UPGRADE BULLETIN:
161103REV

PRODUCT(S) AFFECTED:
American Allegiance,
American Dream,
American Eagle,
American Heritage,
American Tradition

SUBJECT:
Inspection of Air Inlet Screen and Removal of "Duck Bill" Drain valve to prevent engine damage

ISSUE DATE:
November 2016

Figure 1 - "duck bill" drain valve

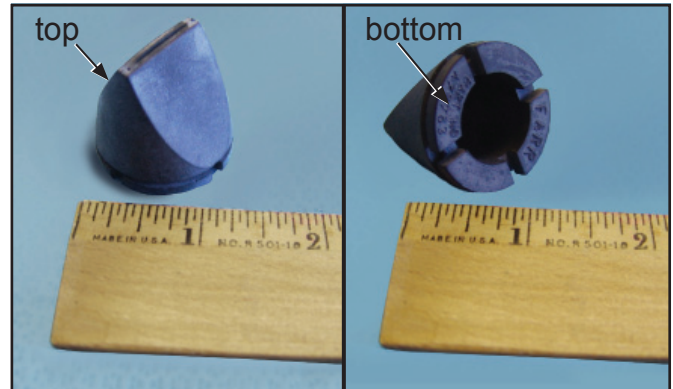
The air box "duck bill" drain valve (shown in Figure 1) may become clogged with debris. **If the engine is started prior to removal of the "duck bill", water may enter the engine and cause extensive engine damage, and may render the engine inoperable.**

4. Open the rear motor access door and look directly up into the center of the opening at the top. See Figure 1. Locate the access panel with 1 ½” opening in it. Insert a pair of needle nose pliers up approx. 1” inside the opening in the access panel. Grasp the rubber portion of the “duck bill” with the pliers and pull down to remove it from its mounting plate. This completes the procedure.
